DeKalb County Historic Preservation Commission

Staff Report

G. 449 Chelsea Circle, Lance Muller. Install driveway and parking pad, construct wall, and plant trees in front yard. **1246874.**

Summary

Sheet Title
Planting Plan

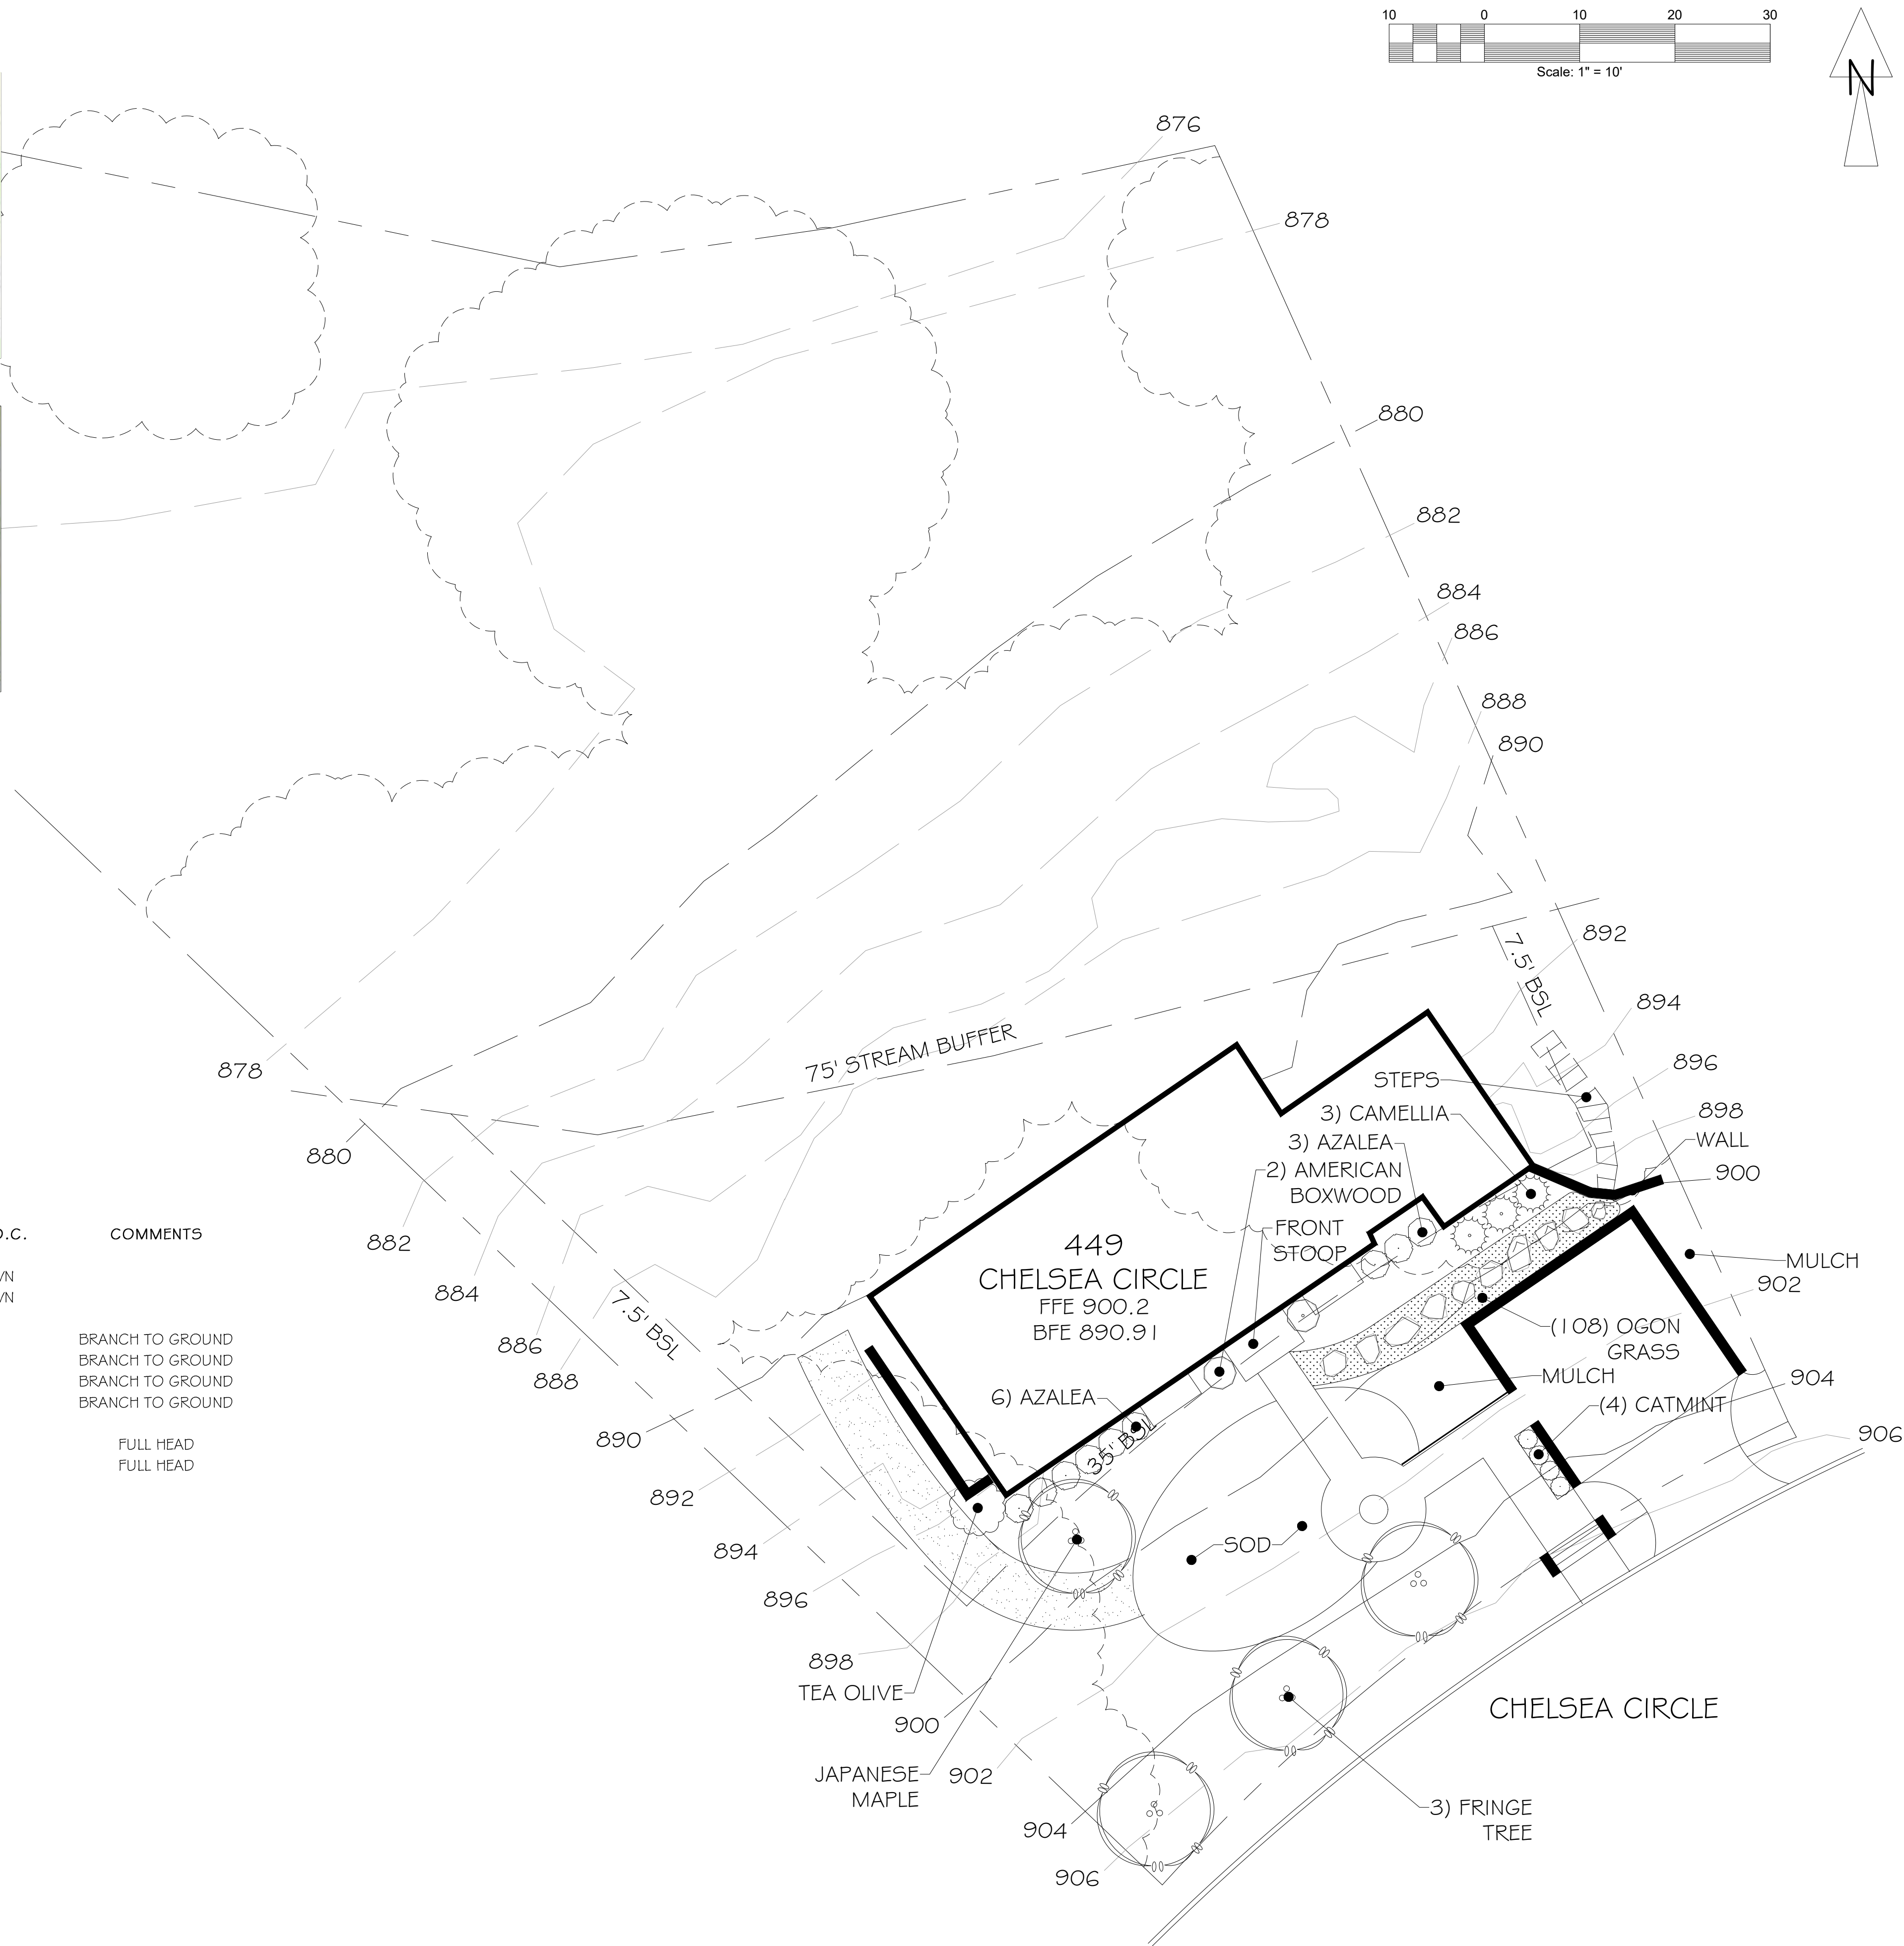
Applicant proposes a modified design for a previously approved retaining wall, parking pad, and landscaping in the front yard of property. The new design proposes installing a concrete driveway and square parking pad on the right-side of the front yard, parallel to the main house. A 3' poured-in-place concrete retaining wall will be installed to the left-side of the house to support the parking pad. A vehicle rail will be installed along the front of the parking pad.

The design also proposes installing a concrete pathway that leads from Chelsea Circle and connects to the parking pad, with a small roundabout connecting the pathway to the front entrance. Metal handrailing will be installed along the pathway leading from Chelsea Circle and the parking pad.

The proposed landscaping in the front yard will include the installation of steppingstones between the parking pad and home, leading from side yard to the front entrance, and the laying of mulch over jute mesh between the sidewalk and the pathway round-about. The new design proposed will retain sections of lawn in the front yard that were paved over by concrete in the previously approved design.

Approve. These proposed changes do not appear to have a substantial adverse effect on the district. This application appears to meet the guidelines and the staff recommends approval.

Sheet Title
Planting Plan

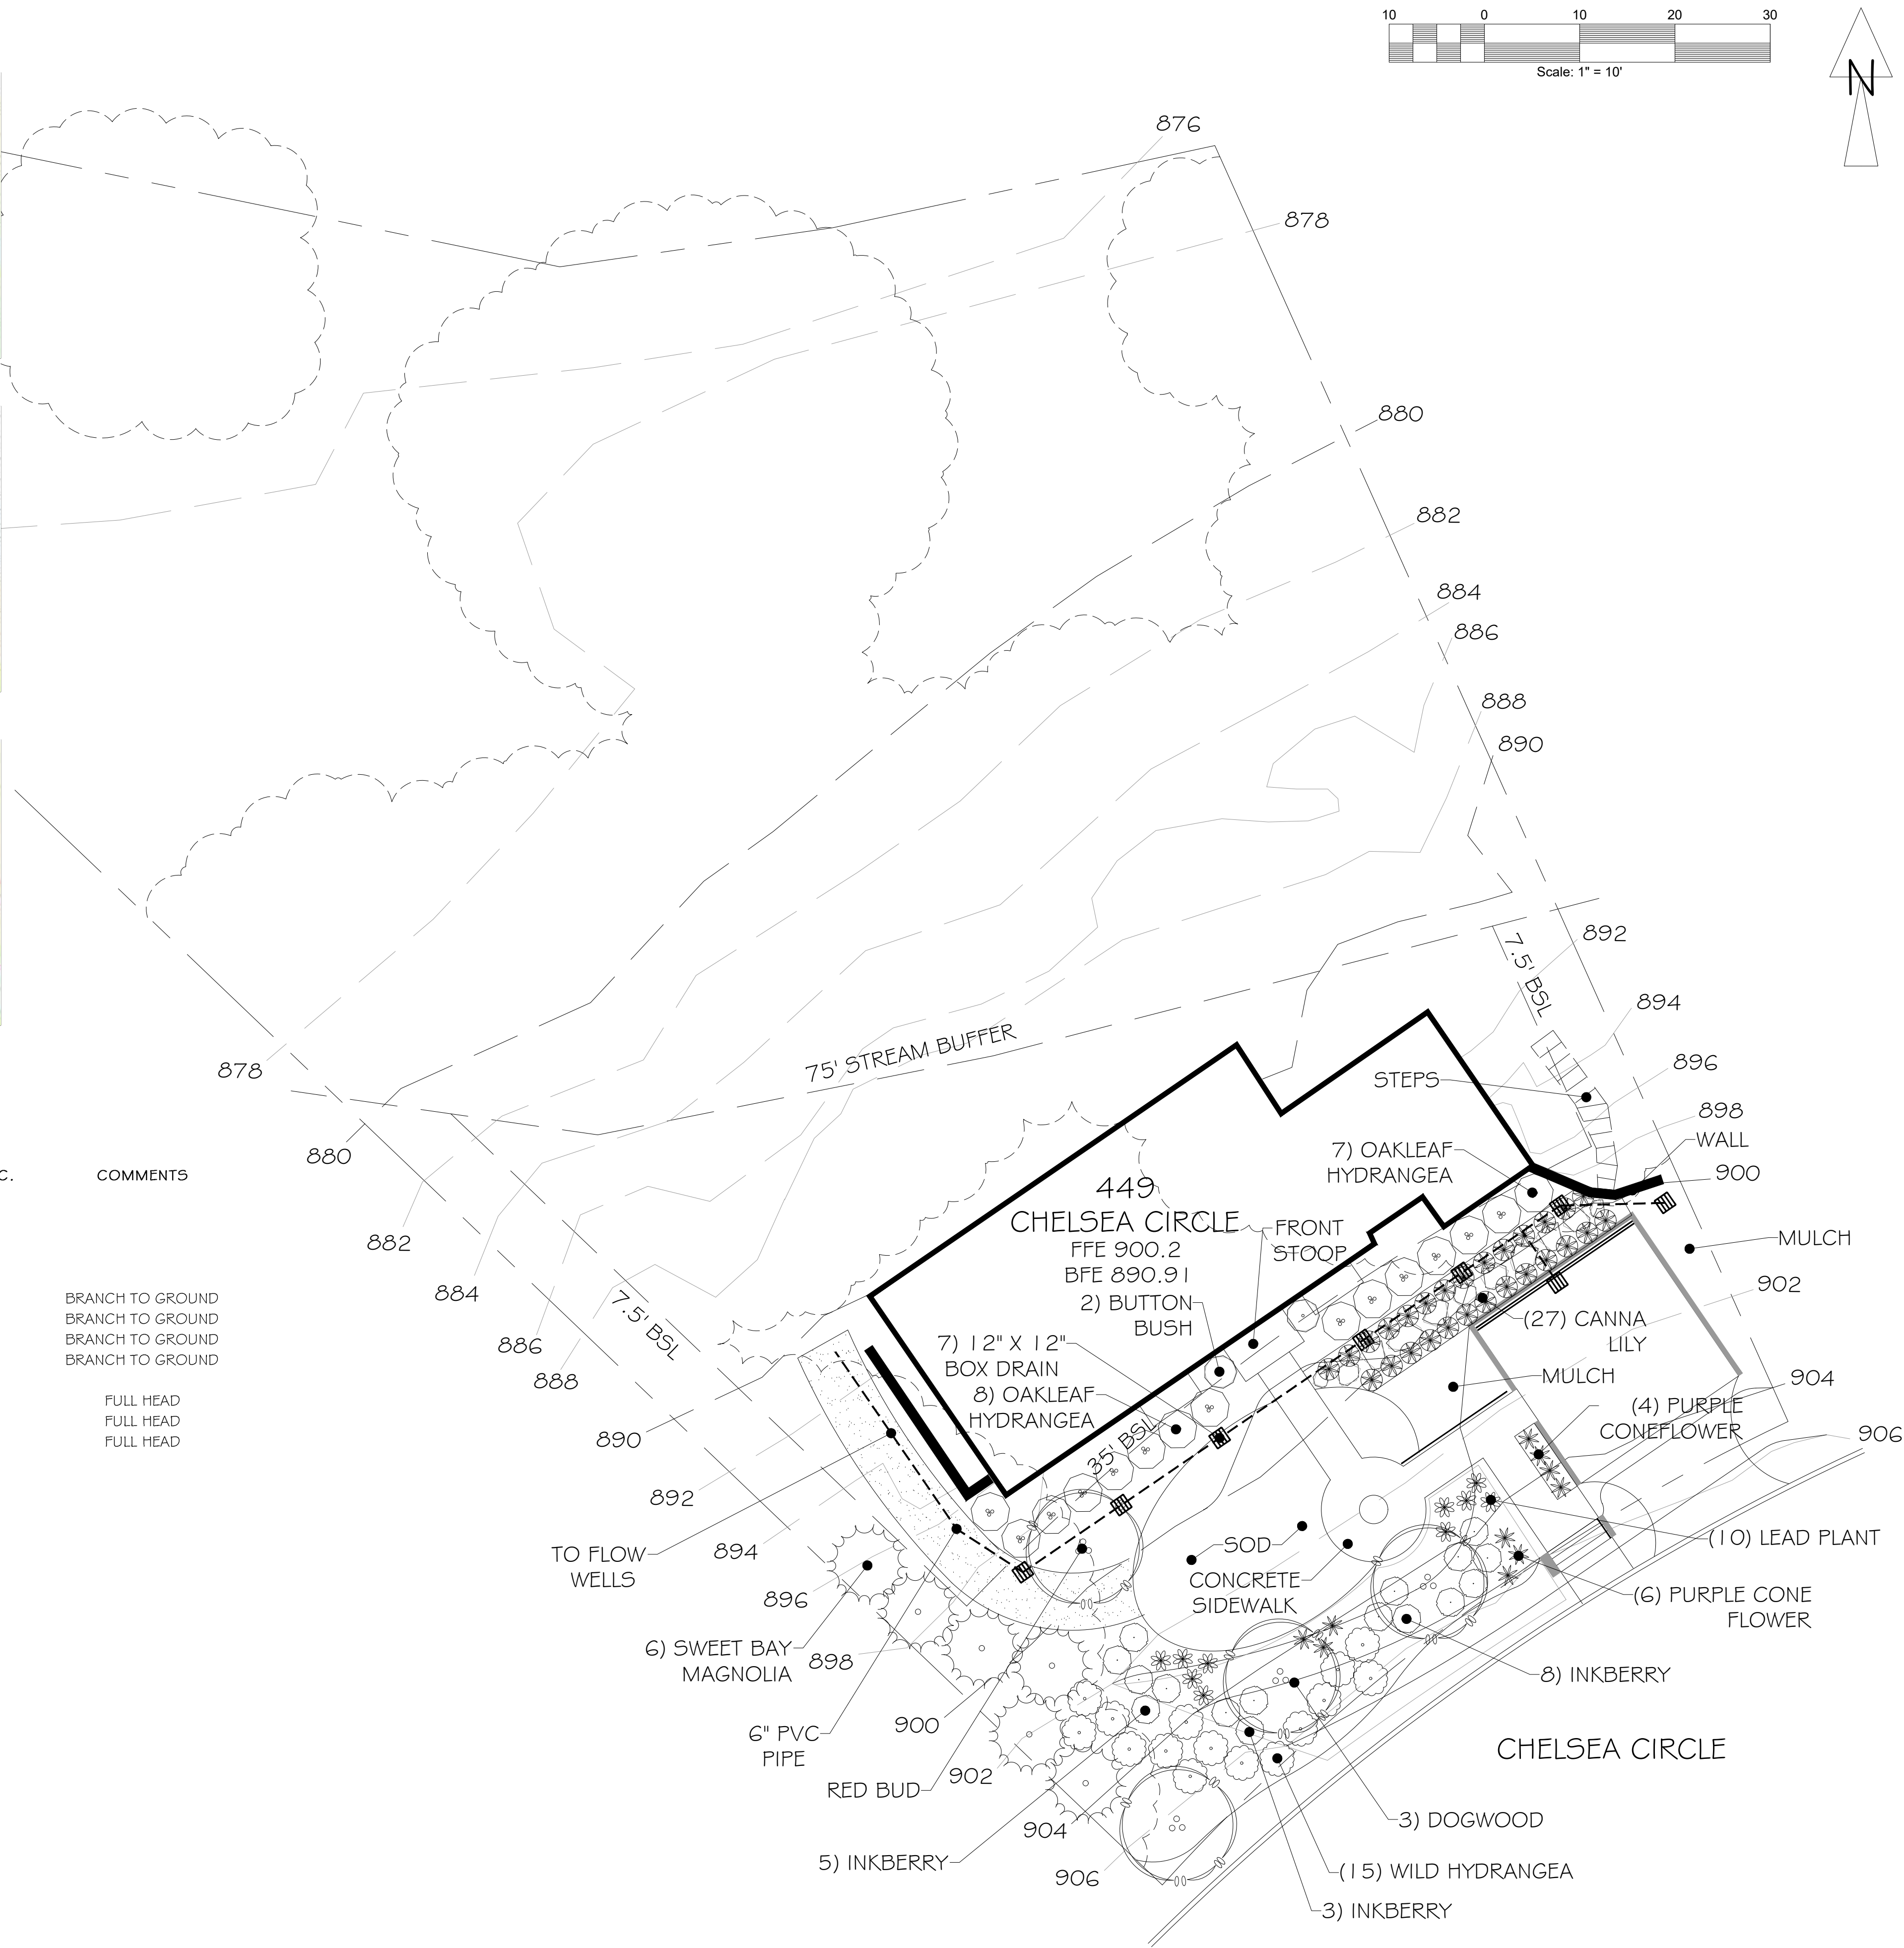
The applicant proposes an updated landscaping plan that including the planting of the following vegetation in the front yard, along the front and left property lines and the front façade of the main property:

- Red Bud (*Cercis Canadensis*)
- Dogwood (*Cornus Florida*)
- Sweet Bay Magnolia (*Magnolia Virginiana*)
- Oakleaf Hydrangea (*Hydrangea Quercifolia*)
- Wild Hydrangea (*Hydrangea Arborescens*)
- Inkberry (*Ilex Glabra*)
- Button Bush (*Cephalanthus Occidentalis*)
- Lead Plant (*Amorpha Canescens*)
- Canna Lilly (*Canna Indica*)
- Purple Cone Flower (*Echinacea Purpurea*)

Sod will be installed in the center portion of the front yard where the concrete roundabout walkway will be located. A 12" x 12" box drain will be installed in front the main property, near the front entrance and walkway.
